Proposal for a new supplement to the 05, 06 and 07 Series of Amendments to UN Regulation No. 83

I. Proposal for Regulation No. 83

Figure 5/2
 Particulate sampling probe configuration

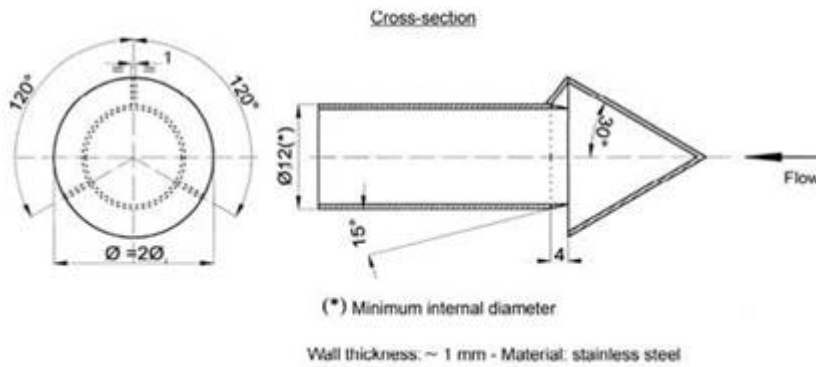
Example 1: particulate sampling system

ECE R83/05 Annex 4 Appendix 5 shall be as indicated

- 2.4.4. The particulate sampling system shall consist of a sampling probe in the dilution tunnel and two series-mounted filters. Quick-acting valves shall be located both up and downstream of the two filters in the direction of flow.

The configuration of the sample probe shall be as indicated in Figure 5/2.

UN R 154 pre-classifier may be used
